Docket No. 50-423  
B18157

Millstone Nuclear Power Station, Unit No. 3  
License Amendment Related to the Supplementary Leakage Collection and  
Release System (PLAR 3-98-5), Supplemental Information

License Amendment Related to the Supplementary Leakage Collection  
Release System (PLAR 3-98-5)  
Response to Requests for Additional Information

Figure 1 - Plant Isometric

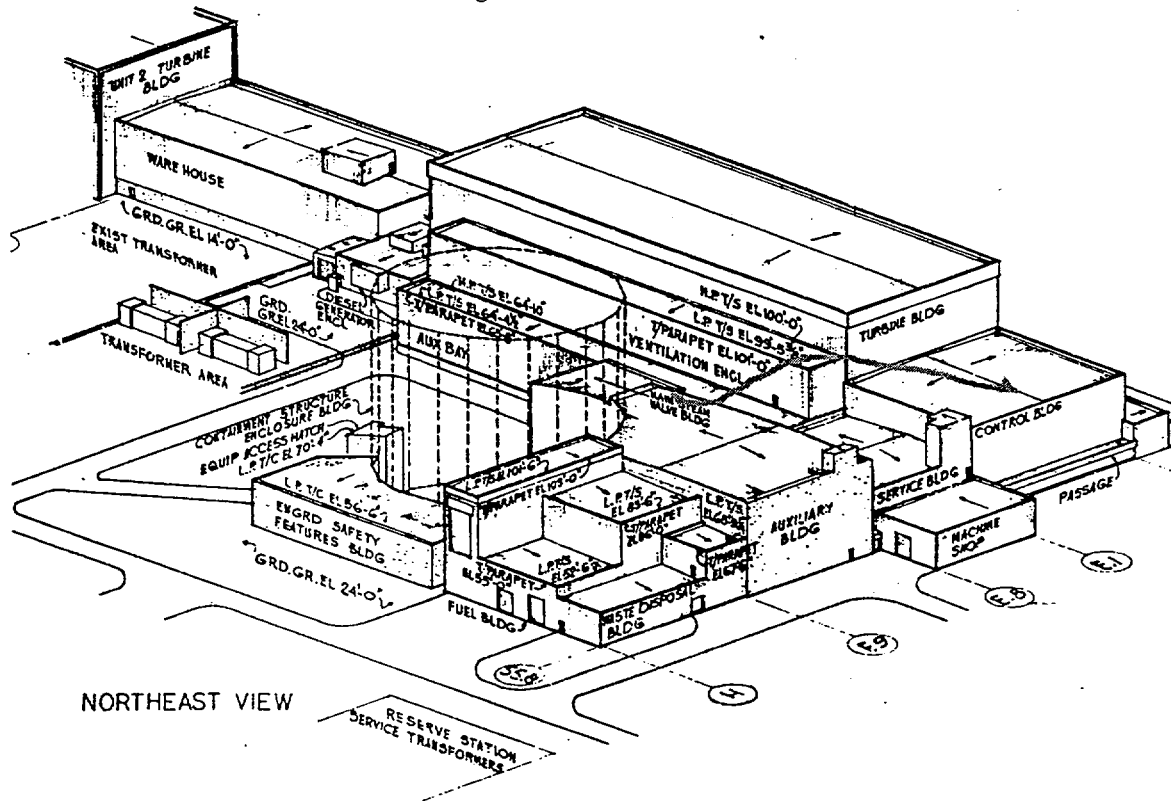
**Stone and Webster calculation dated May 27, 1998, on X/Qs from the Unit 3 main steam building (MSVB) states that the postulated effluent release for the MSVB bypass scenario does not meet the Murphy-Campe criteria for using the diffuse source equation. However, a general statement is made that because of multiple flow disruptions due to buildings both upwind and downwind of the release, it is reasonable to assume that this equation may be used to estimate resultant X/Q values. The calculation assumes that the release occurs from the vent closest to the control room intake and mixes in the wake of the MSVB.**

S&W calculation WM(B)-01, dated May 27, 1998, calculates the X/Q from the Unit No. 3 Main Steam Valve Building (MSVB) to the MP3 control room using the diffuse source equation of Murphy-Campe. The diffuse source equation was used to estimate the X/Q even though the elevation difference between the MSVB release point and the control room intake meet the criteria of the point source - point receptor technique of Murphy - Campe. The justification for using the diffuse source equation is based upon the aerodynamic obstacles encountered by the plume in the straight line pathway between the two points. Figures 1 and 2 depict the postulated flow path that the plume would have to travel from the MSVB to the Unit 3 control room intake.

The MSVB has two exhaust vents as shown in Figure 2. These vents (elev. 85.9') are physically located between the containment structure and the Aux. Bay/Ventilation Enclosure structures. The MSVB vents discharge downward. The closest vent to the

control room intake is considered in the X/Q calculation. The prevailing wind necessary to transport postulated radioactivity released from the MSVB to the control room intake would need to flow around the containment structure, entrain the MSVB effluent discharged downward, flow up and over the Ventilation Enclosure roof (elev. 100'), be effected by the turbulent flow created by skirting the turbine building corner (elev. 132') at approximately a 45 degree angle, then decrease in elevation to the control room intake (elev. 94.6'). The accumulated affect of containment structure building wake and complex aerodynamic forces and obstacles encountered in the pathway between the source point and receptor, were justification for using the diffuse source equation of Murphy-Campe for this pathway.
